**Item 8.****Development Application: 133-141 Liverpool Street Sydney - D/2018/1144****File No.:** D/2018/1144**Summary**

<b>Date of Submission:</b>	21 August 201. Amended plans were received on 19 April 2019 and 23 November 2019
<b>Applicant:</b>	The Trustees of the Roman Catholic Church for the Archdiocese of Sydney
<b>Architect:</b>	Candalepas Associates
<b>Developer:</b>	The Trustees of the Roman Catholic Church for the Archdiocese of Sydney
<b>Owner:</b>	The Trustees of the Roman Catholic Church for the Archdiocese of Sydney
<b>Cost of Works:</b>	\$161,592,926
<b>Zoning:</b>	The site is zoned B8 - Metropolitan Centre, with the indicative uses of commercial and residential permitted with consent.
<b>Proposal Summary:</b>	<p>The application is a concept proposal for in-principle approval for demolition of the existing commercial buildings on-site and a building envelope to a height of approximately 234m.</p> <p>The indicative future land uses consist of retail and commercial within the podium and residential apartments within the tower.</p> <p>The indicative scheme submitted with the application demonstrates that the envelope is capable of accommodating up to 24,083 square metr

**Figure 8:** Floor plan of proposed tower form, hatched area indicates potential for reduced setback (with no windows facing onto reduced setbacks)

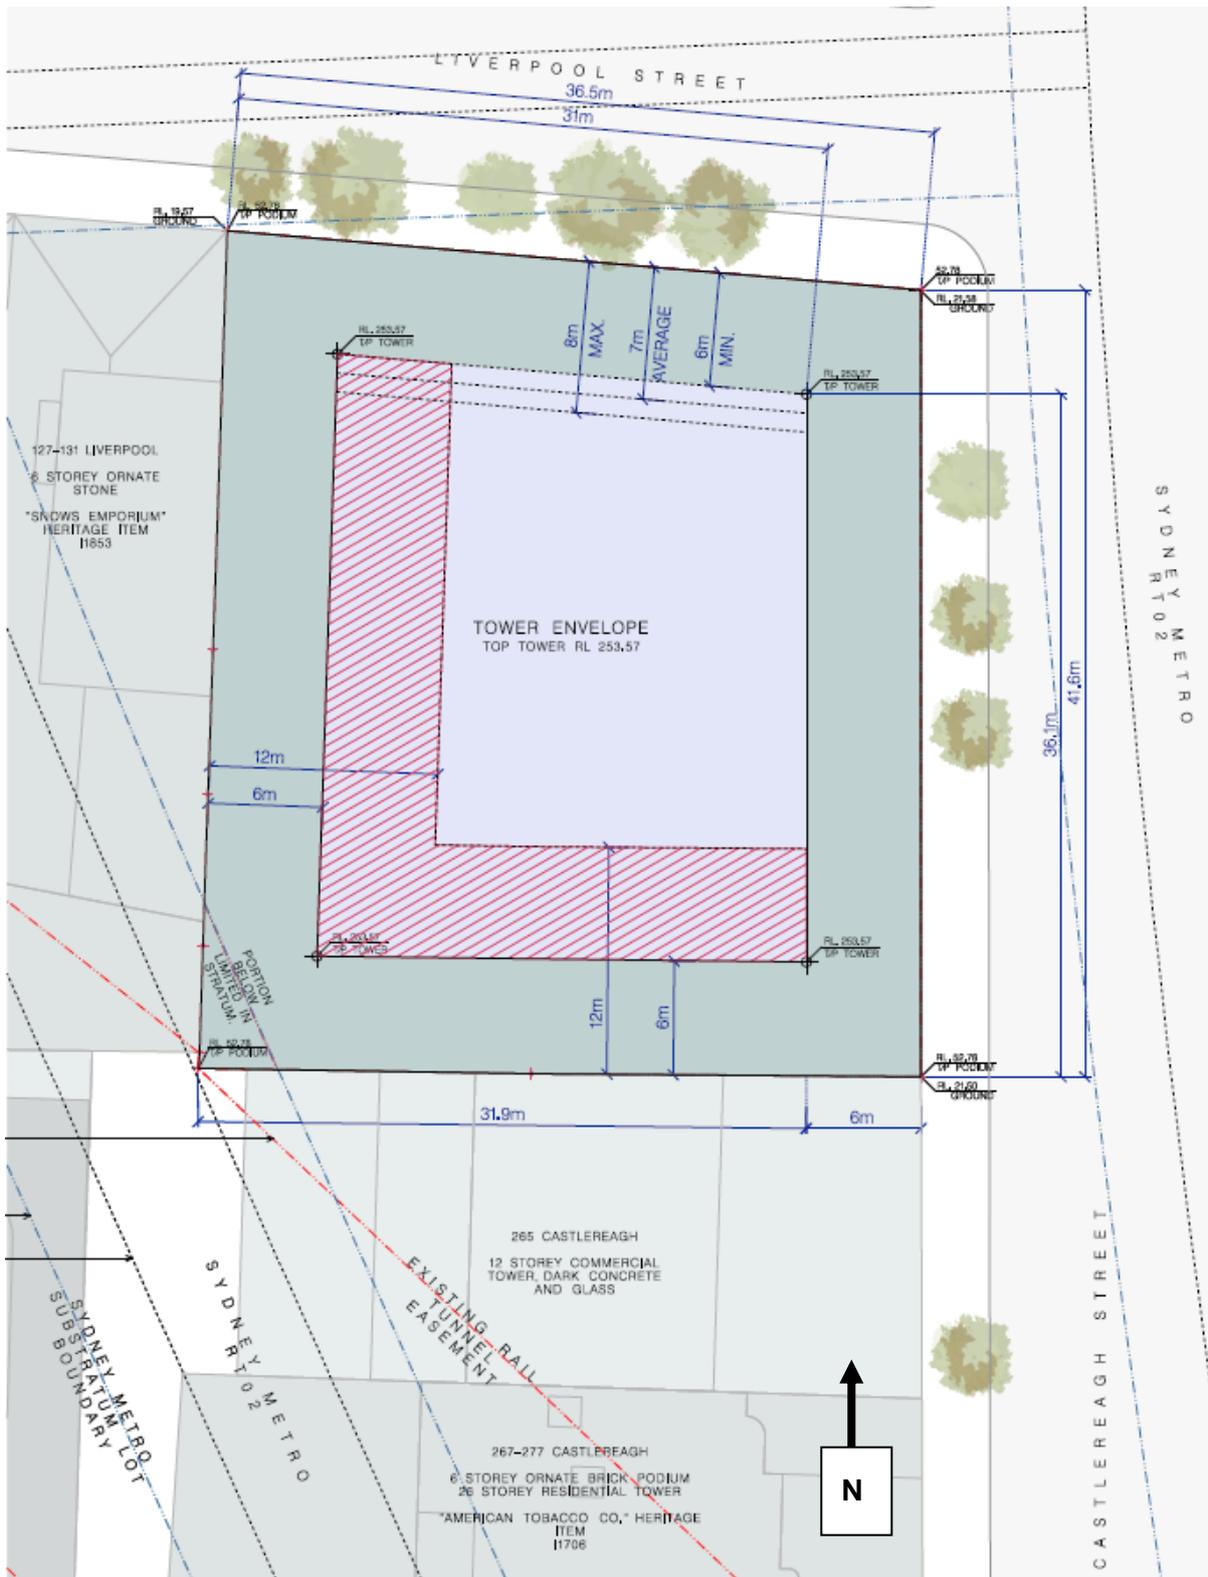
5.1.2 Building setbacks	No	<p>The DCP requires that buildings must be set back a minimum weighted average of 8m above the required street frontage height.</p> <p>This setback may be reduced in part by up to 2m provided that the weighted average setback from the street frontage alignment is 8m. No part of the building is to be setback less than 6m.</p> <p>The weighted average setback may be reduced on secondary or minor pedestrian streets, provided that an average weighted setback of at least 8m is maintained on north-south streets and/or major pedestrian streets.</p>

<p>A 6-8m (averaging 7m) tower setback from the Liverpool Street boundary is proposed. A 6m setback along the Castlereagh Street frontage is proposed.</p> <p>A reduction in setback along Liverpool Street is not supported.</p> <p>See further discussion in the Issues section of this report.</p>
5.1.4 Building bulk	Yes	<p>Above a height of 45m, the control restricts floor plates to a maximum of 1000sq.m with a maximum horizontal dimension of 40m.</p> <p>At 795sq.m and 30.5m the floor plate will be compliant.</p>

49. It is recommended that the proposal be amend via condition to provide a DCP compliant setback to Liverpool Street of a weighted average of 8m. A complaint setback to Liverpool Street would in turn result in the 6m setback to Castlereagh Street being compliant with the provisions of the DCP.

**Figure 12:** Envelope floorplan with reduced setback zone hatched

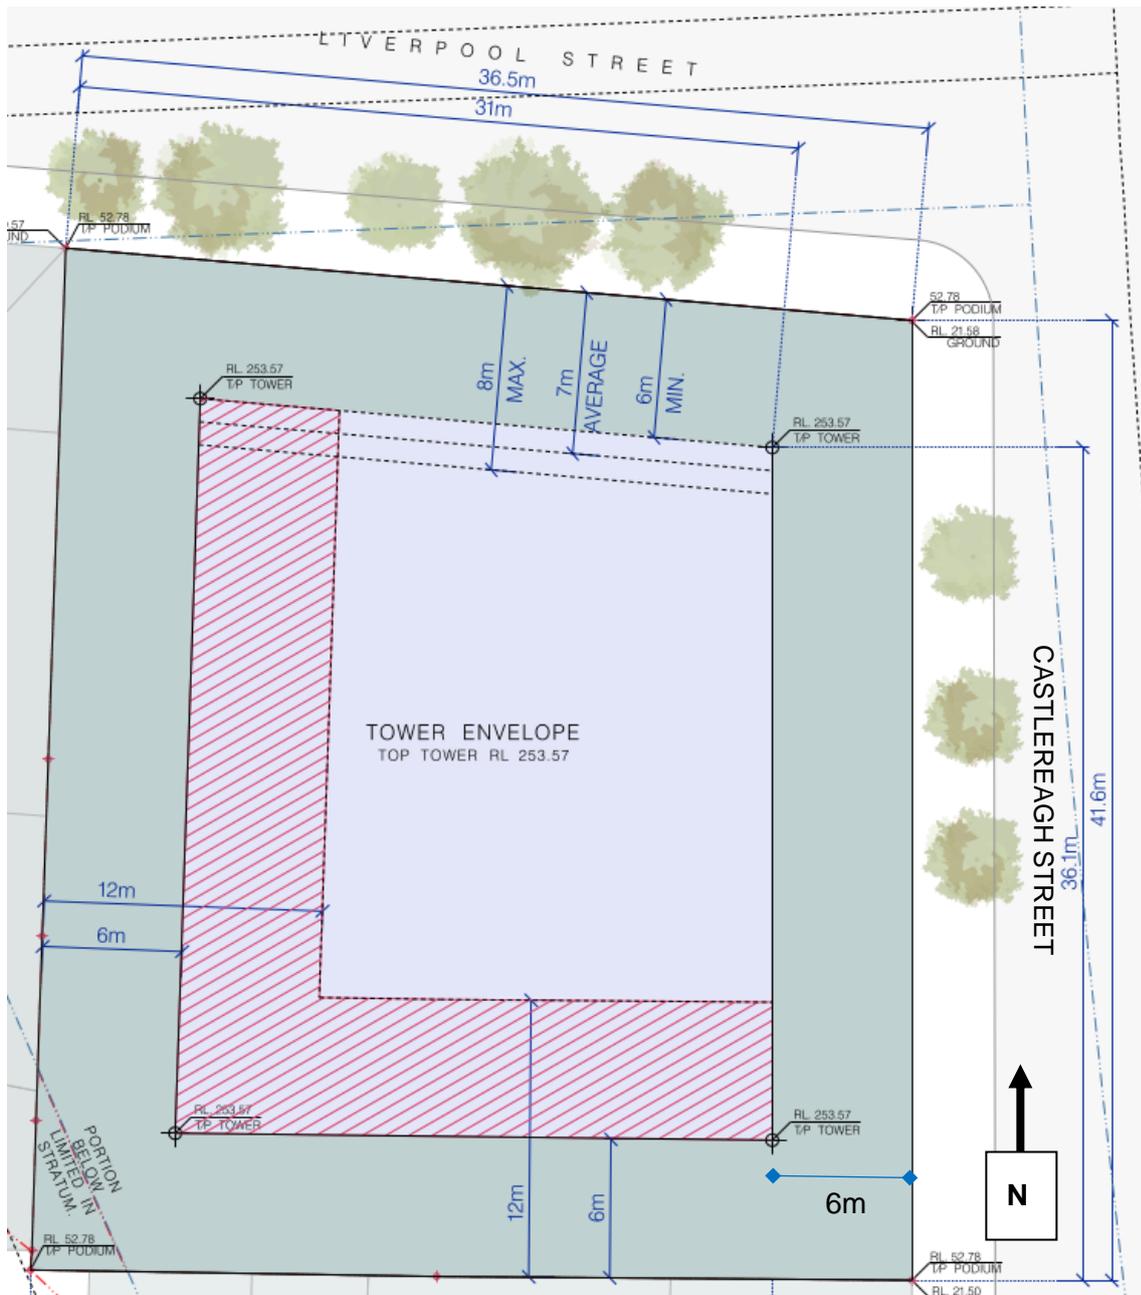
33. To achieve the building separation requirements of SEPP 65/ADG, the proposed tower envelope would need to provide a setback of 12m from the southern and western boundaries of the site to provide a 24m separation between habitable rooms of the subject site and the neighbouring properties.

34. The proposal provides a 6m setback from the proposed tower and the western and southern boundaries. While not determinative it is worth noting that the immediately adjoining neighbouring buildings to the south and west do not have primary residential windows or balconies facing towards the site. The property immediately to the south of the site is a commercial building with a row of secondary facing north adjacent to the property boundary.

35. The submitted drawings (Attachment B) identify the area of the envelope within 12m of the southern and western boundaries as being a "Reduced setback zone" with 'openings to meet SEPP 65/ADG requirements'. The submitted envelope is shown below.

36. The effect of this notation is to ensure that SEPP 65/ADG compliant separation can be achieved through the orientation of windows and balconies in a future Stage 2 development application.
37. The submitted indicative scheme (below) demonstrates that SEPP 65/ADG compliance can be achieved through the orientation of windows and balconies away from the southern and western boundaries of the site. Given that the most desirable outlook from the site is to the north east towards Hyde Park the proposed arrangement and massing of the indicative scheme is a reasonably expected outcome

**Figure 13:** Indicative floorplan

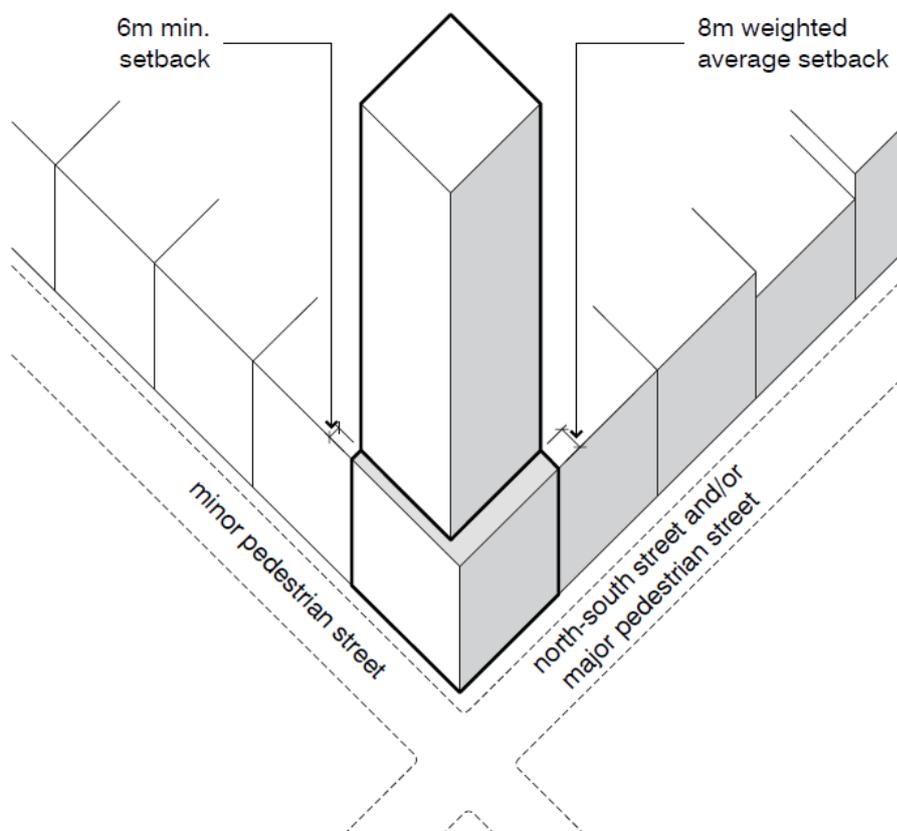
38. By providing blank walls to the southern and western boundaries the indicative scheme complies with the requirements of SEPP 65/ADG as a blank wall does not result in adverse privacy impacts. As noted in 3F of the ADG, no separation is required between blank walls.
39. The proposed tower setbacks to the southern and western boundaries are acceptable. The future detailed development application will have regard to the reduced setback zones identified in the submitted drawings to ensure adequate separation is achieved between balconies and habitable spaces.
